# Work Order ID 96877

Item Name: Crosstube Mid Aft

DART AEROSPACE LTD HAWKESBURY, ONTARIO, CANADA	
DRAWING NO. D206-667-247	REV. A SHEET 1 OF 4
TITLE CROSSTUBE ASS'Y (206L MID AFT)	SCALE NTS
COPYRIGHT © 2010 BY DART AEROSPACE LTD THIS DOCUMENT IS PRIVATE AND CONFIDENTIAL AND IS SUPPLIED ON THE EXPRESS CONDITION THAT IT IS NOT TO BE USED FOR ANY PURPOSES OR COPIED OR REPRODUCED IN ANY MANNER WITHOUT WRITTEN PERMISSION FROM DART AEROSPACE LTD.

DRAWING NO. D206-667-247	TITLE CROSSTUBE ASS'Y (206L MID AFT)	REV. A	<b>DART AEROSPACE LTD ENGINEERING ORDER</b>		D.E.O. NO. D206-667-247-A-1	SHEET NO. SHEET 1 OF 1	SCALE NTS
DRAWN <i>q</i>	CHECKED <i>ASS</i>	MFG. APPR. <i>KD</i>	APPROVED <i>MD</i>		DE APPR. <i>HA</i>		
DATE 11.07.15	DATE 11.07.20	DATE 11.07.21	DATE 11/07/21		DATE 11.07.21

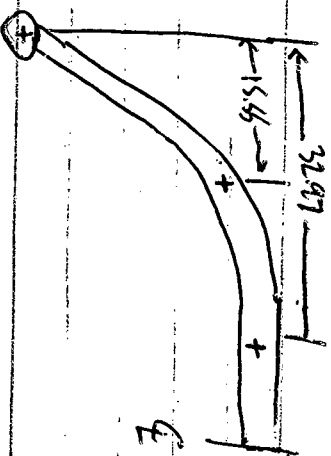
REPLACE MAGNOBOND WITH PROSEAL.

NOTE 12 & 15, SHEET 1 IS AMENDED AS FOLLOWS:

WAS:

- 12) INSTALL D2892-1 SUPPORT USING 0.03" TO 0.06" THICK LAYER OF MAGNOBOND 6398 PER QSI 015. LET CURE FOR 12 HOURS AFTER INSTALLATION AND PRIOR TO PACKAGING.
- 15) TORQUE CLAMPS 80 TO 100 IN-LB. ENSURE AT LEAST 1.5 THREADS SHOWING IN SAFETY AND THAT NUT HAS NOT BOTTOMED-OUT AFTER TORQUING.

IS:

- 12) TO INSTALL D2892-1 SUPPORT: ABRASE MATING SURFACE OF SUPPORT AND CROSSTUBE WITH 180-GRIT SANDPAPER AND REMOVE RESIDUE WITH MEK (OR EQUIVALENT). APPLY A 0.04" TO 0.07" THICK LAYER OF PROSEAL 890 CLASS B-2 (OR AMS-S-8802 CLASS B-2) SEALANT TO MATING SURFACE OF SUPPORT.
- 15) TORQUE CLAMPS 80 TO 100 IN-LB. ENSURE AT LEAST 1.5 THREADS SHOWING IN SAFETY AND THAT NUT HAS NOT BOTTOMED-OUT AFTER TORQUING. **PRIOR TO PACKAGING, RE-CHECK TORQUE ON CLAMPS AFTER PROSEAL 890 SEALANT HAS CURED FOR 72 HOURS.**
